November 8, 2017

Re: Planning Board Peer Review Letter #1/ Conservation Commission Peer Review
Letter #2. Peer Review of Hydrologic Concerns.
Proposed Evergreen Commons, 18 Boyd Drive, Newburyport, MA

FIGURE 8

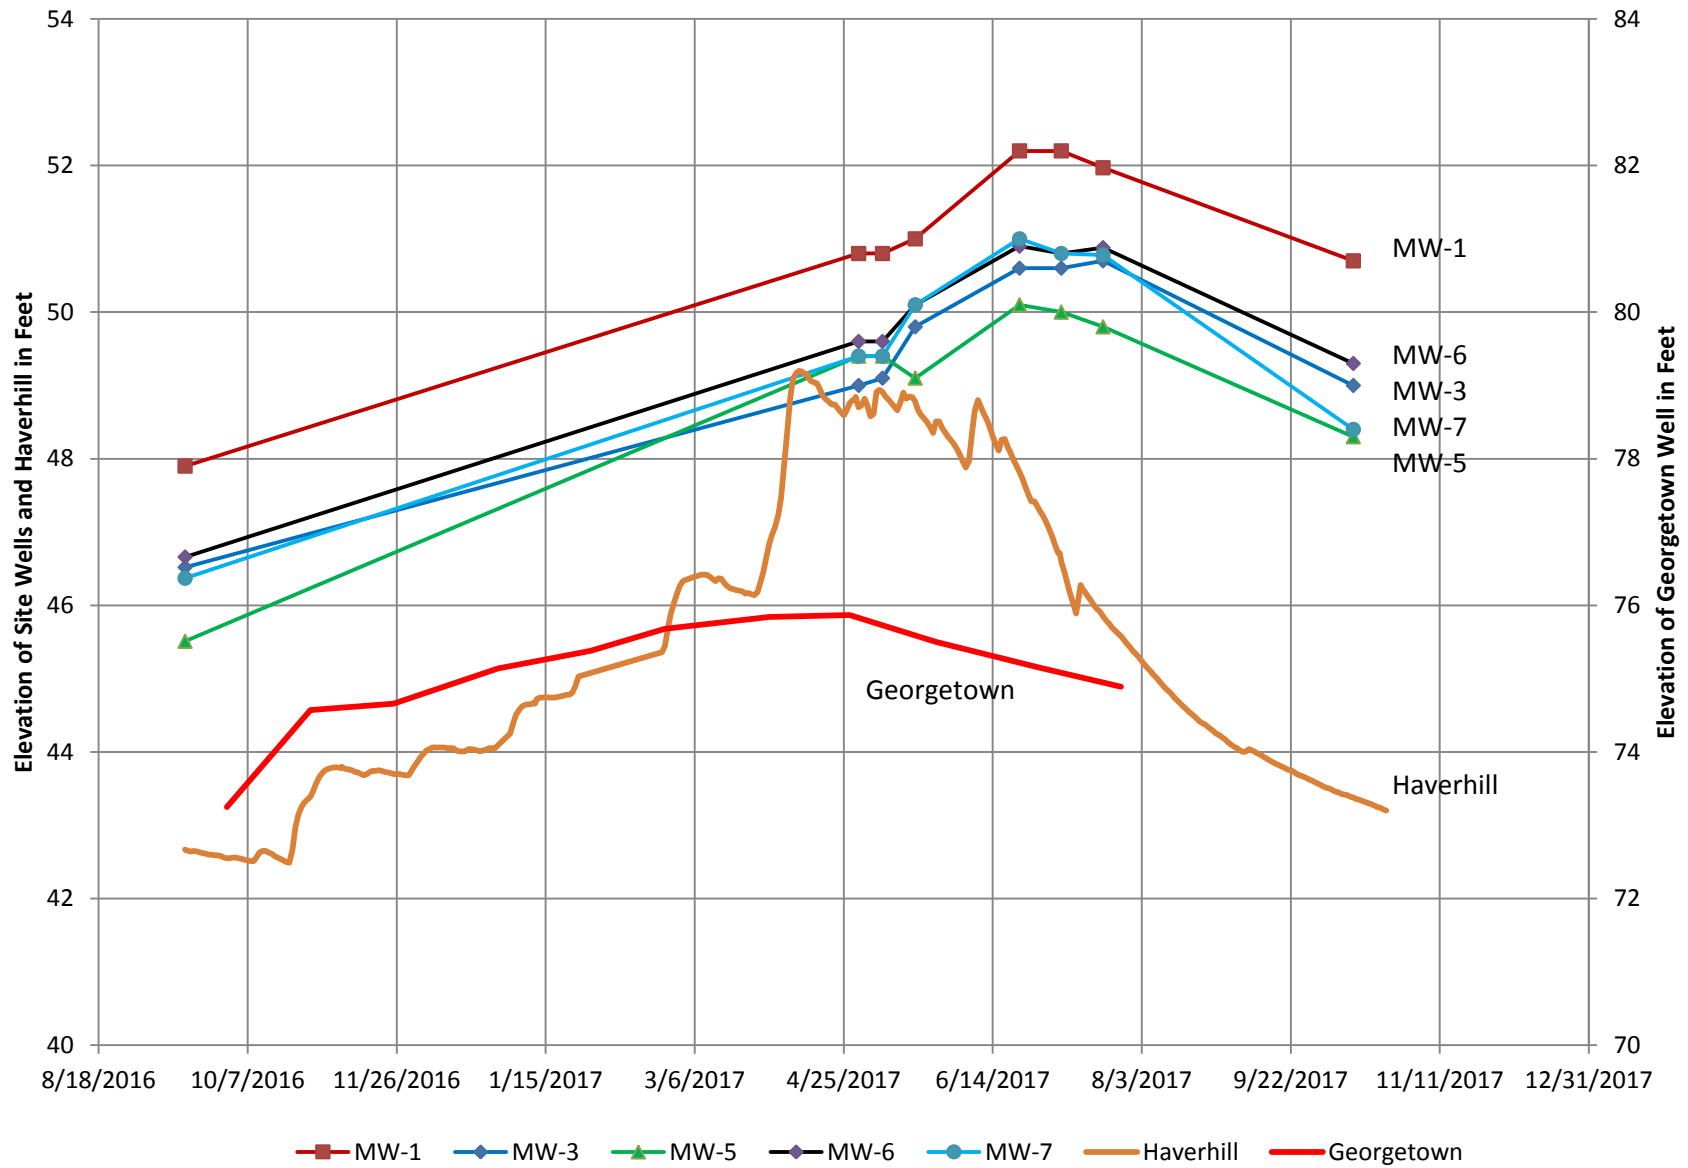
We do note that the two local groundwater maps that we are aware of both show a groundwater flow direction from the eastern part of the site to the north/northeast, towards the City Well #2 (BSC Group August 22, 1985; NGL, September 2016). Those maps are included herein as Attachments 2 and 3. However, both of those groundwater contour maps reflect summer conditions when City Well #2 is in operation and is creating a cone of depression in the water table that directs groundwater flow towards itself. It is unknown, though it seems reasonable, that during the winter/spring when Well #2 has not been operational for some time the groundwater flow direction would become more northerly and less northeasterly.

- 3.2 The two available groundwater flow maps for the site (both during summer pumping conditions as described above) show flow split on the site by a potential bedrock ridge, with flow from the area of the existing and proposed wetlands heading north towards the Merrimack River and flow from the eastern portion of the site heading northeast towards City Well #2. To our knowledge, the theoretical existence of that bedrock ridge is based on one boring conducted by the BSC Group in the 1980's and another by the Applicant as part of this proposed development application. As discussed above, the one recent boring log that we reviewed does show bedrock at a high enough elevation to represent at least a partial hydraulic barrier between east and west. However, the extent and continuity of that bedrock high are unknown. Even if that bedrock high does not create a continuous hydraulic barrier, our examination of the available water level data from the site and City property indicates that, at least during the wintertime non-pumping season, flow from the wetlands area of the site likely heads north towards the Merrimack River. Flow from this area may head towards City Well #2 during the summertime pumping season.

Attachment 5 - Hydrographs of City and USGS Water Level Data

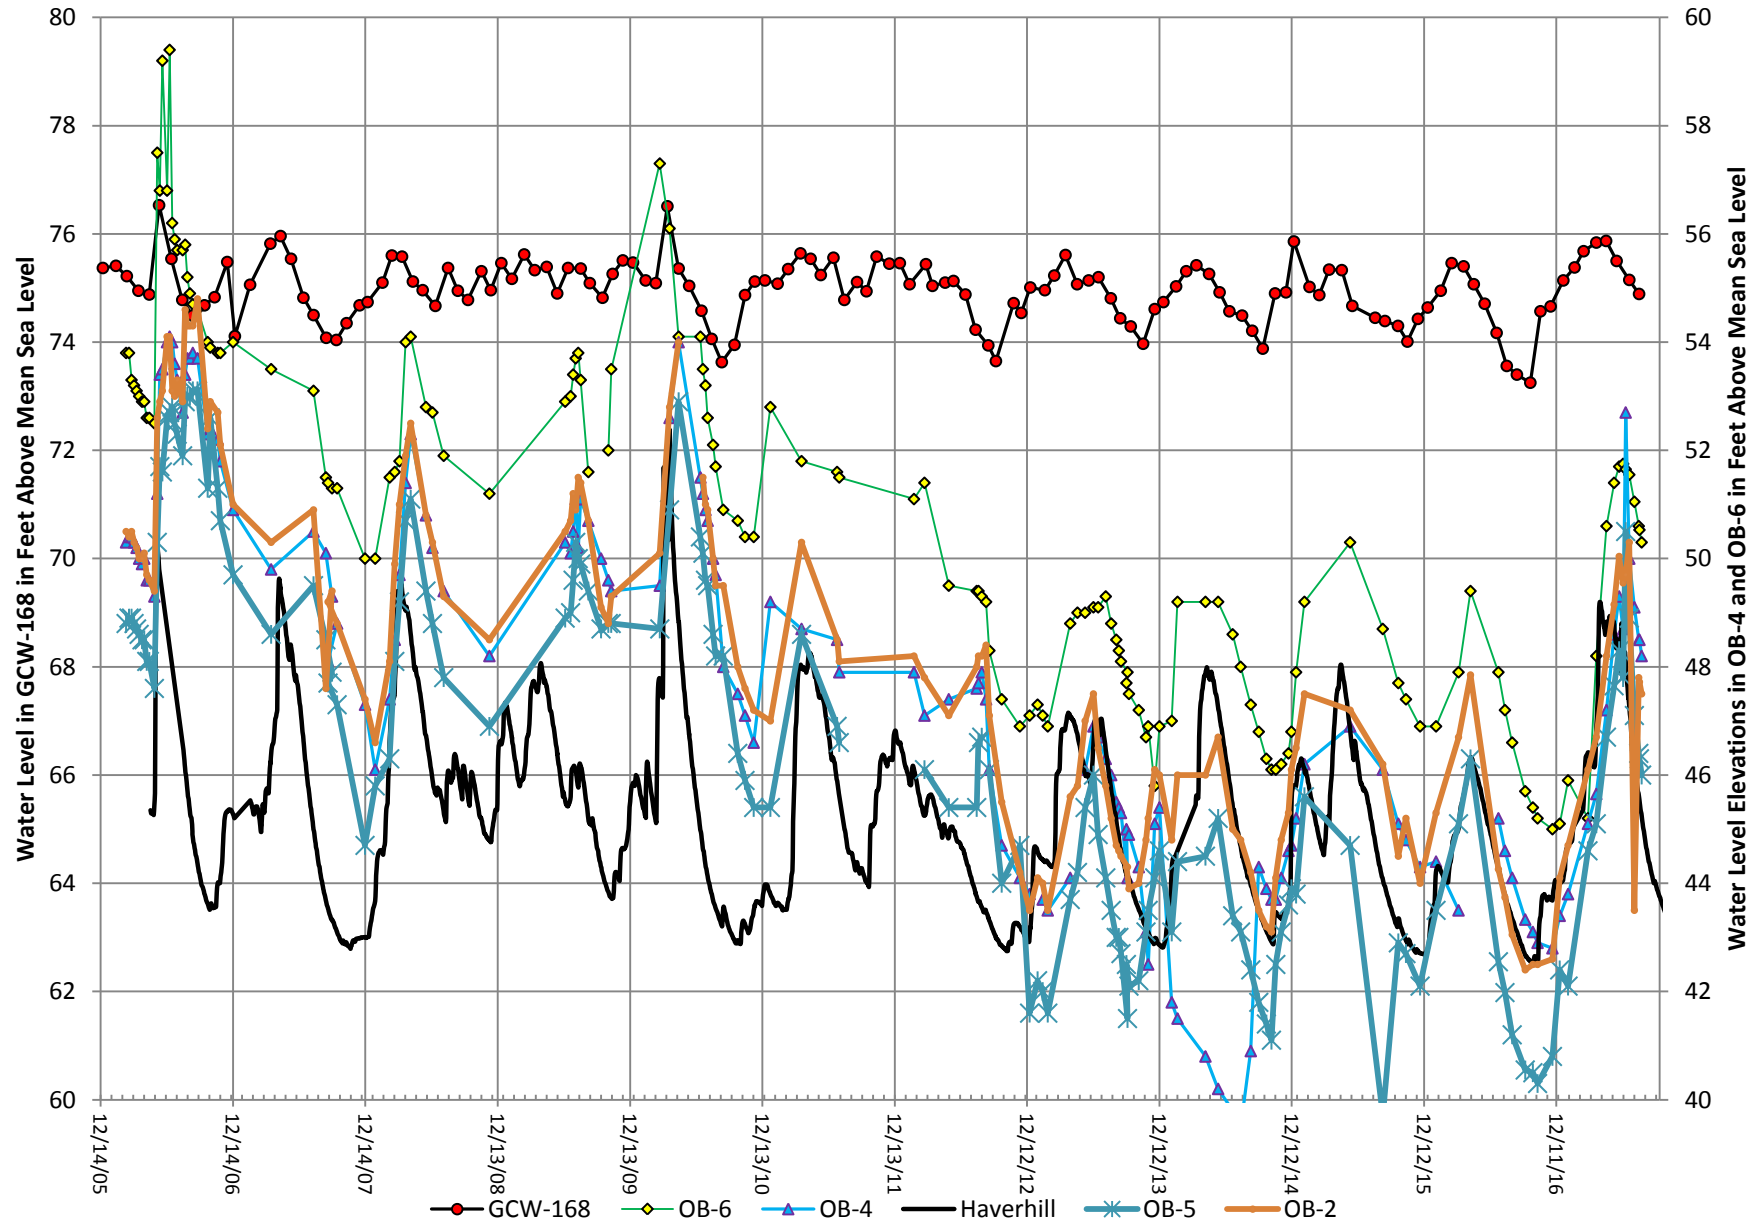
All, or nearly all, of those site measurement rounds were during time periods when City Well #2 may have been operational (reported to us by NGI and DCI as being primarily during the peak summer water demand period). In contrast, there is a far more extensive data set of water levels from monitoring wells on the City property from 2006 through August 2017. That data set was supplied to us by NGI. Over the two data sets common time period of September 2016 through September 2017, City monitoring wells have exhibited water elevations varying between approximately 40 and 52 feet (NAVD 88). Over that same time period site wells have varied between approximately elevations 45 and 52 (Attachment 5, HW modification of NGI figure). Therefore, at least for the limited data overlap time period, water levels on the City property fall lower than those at the site (likely due to the influence of pumping), and rise to approximately the same high levels during the winter/spring.

Attachments 6 and 7 illustrate “zoomed in” views of the earlier and later time periods, respectively, of the Attachment 5 data record. Attachments 5, 6, and 7 are all HW modifications of a figure originally created by NGI. HW added additional City monitoring well data records to the figure and highlighted our understanding of the general pumping vs. non-pumping time periods for City Well #2. We interpreted the summer pumping period to be June through September. Close examination of the highlighted pumping periods (reflecting the time frame of City use of Well #2 reported to us by DCI and NGI) on Attachments 6 and 7 reveals that the highlighted June through September times generally coincide with declining water levels in City observation wells, as one would expect. However, it is also evident that the match is not perfect; sometimes the time period of declining water levels is a little longer than the highlighted time frame, sometimes it is a little shorter and, occasionally, it does not match closely. This indicates to us that City use of Well #2 is more variable over time than simply during the high summer water demand season.

- We note on Attachments 5 that in the time span from 2009 through 2012 all City property observation wells exhibited a downward trend in water levels over and above the regular seasonal fluctuations observed before and after. From 2012 to the present those groundwater levels have continued to fluctuate around an average elevation generally about four feet lower than the average elevation from 2005-2009. The two USGS Index Well data records also shown on Attachment 5 do not exhibit that same pattern, indicating that the effect is not climatically induced but, instead, is caused by something of local origin. This means that either there was some systematic change in how groundwater levels were measured and recorded at the City property over this time period or some local hydraulic factor has changed. Local hydraulic factors might include a systematic increase in average water withdrawals from City Well #2 or a diversion of stormwater recharge away from the City property (changing stormwater management from I-95 is one possibility for a stormwater change, although we do not know if this has occurred). Investigation of the potential cause for this change is beyond the Scope of this peer review.
